BULLETIN: #T-61-35

SUBJECT: HERALD INNER AXLE SHAFT

INNER AXLE SHAFT (MODIFIED CIRCLIP GROOVE)

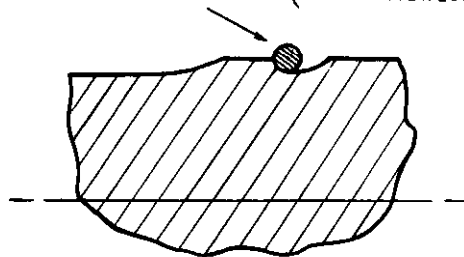
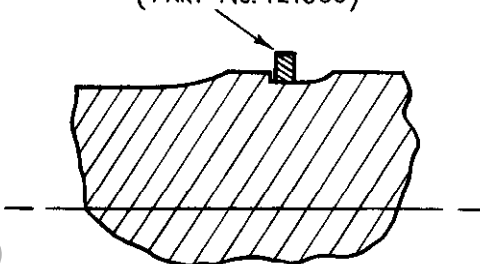
Inner half shaft rear axle assemblies of units from commission numbers GA-35604 and Y-31501 incorporate a revised circlip groove. These shafts may be used to replace the earlier type, provided that the revised circlip is also fitted and the existing thrust washer discarded.

PART No. 132649 — DIM. 'A' 0.643/0.648 (16.33/16.46mm)
PART No. 117661 — DIM. 'A' 0.683/0.685 (17.35/17.40mm)

<u>Item</u>	<u>Existing Part Nos.</u>	<u>Replaced by Part Number</u>
Inner axle shaft assembly	117661	132649
Circlip	121680	132650
Thrust Washer	120327 (No longer required)
